AGENDA
PLAN COMMISSION
Board Room, 3rd Floor
Arlington Heights Village Hall, 33 S. Arlington Heights Rd.
Arlington Heights IL 60005
October 8, 2025
7:30 PM

- I. CALL TO ORDER
- II. ROLL CALL OF MEMBERS
- III. APPROVAL OF MINUTES
 - A. Minutes 9/24/25
- IV. PUBLIC HEARINGS
 - A. 1500 E. Euclid Ave. Subdivision - PC#25-008
Preliminary Plat of Subdivision, Variation
- V. OTHER BUSINESS
- VI. PUBLIC COMMENT

To: Plan Commission
Prepared By: Darko Bojin, Assistant Planner
Meeting Date: October 8, 2025
Date Prepared: September 25, 2025

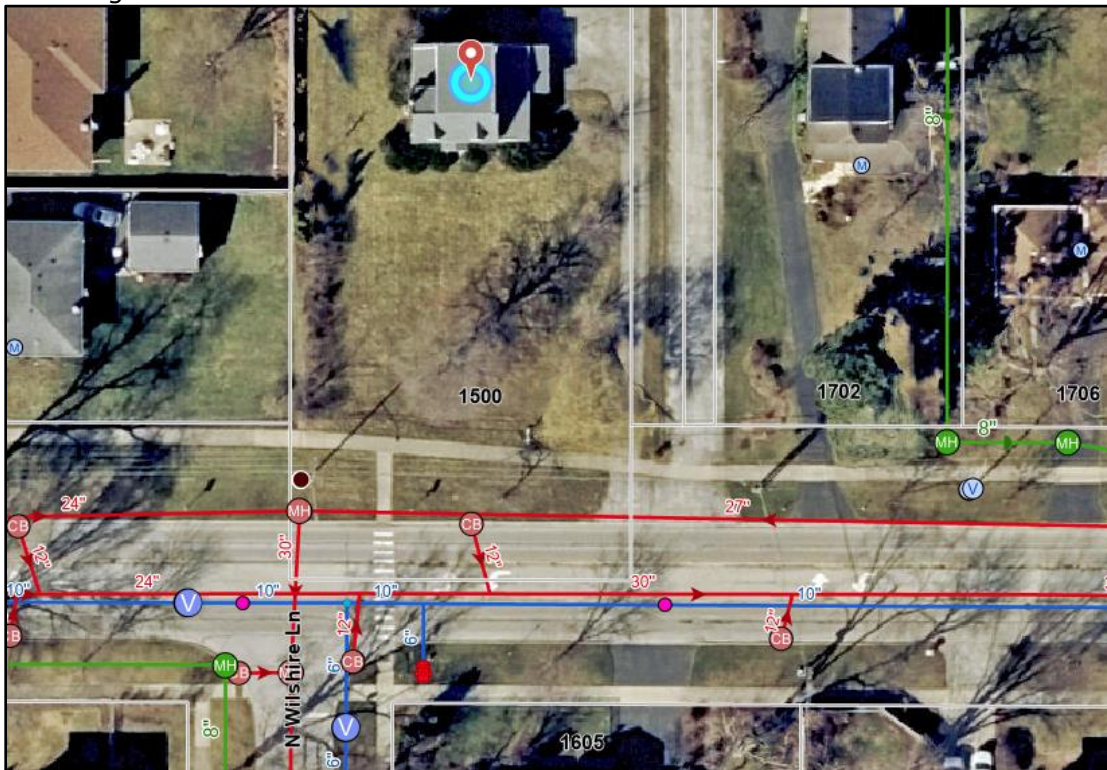
14. The Final Plat of Subdivision must be reviewed and approved by Engineering prior to final Plan Commission approval. The original signed mylar Final Plat of Subdivision, containing all non-Village signatures, shall be submitted one week before the scheduled date of the final Plan Commission meeting. Village Code Section 29-209 also requires a digital copy of the plat to be provided on disk to the Village. The petitioner shall acknowledge that they accept this understanding.
15. Final subdivision approval will require final engineering plans.
16. Provide preliminary engineering for the sanitary sewer extension. An MWRD and IEPA permit will be required for the extension. The location of the existing sanitary sewers is shown in green:

17. The existing well and septic will need to be abandoned. This can be addressed at permit.
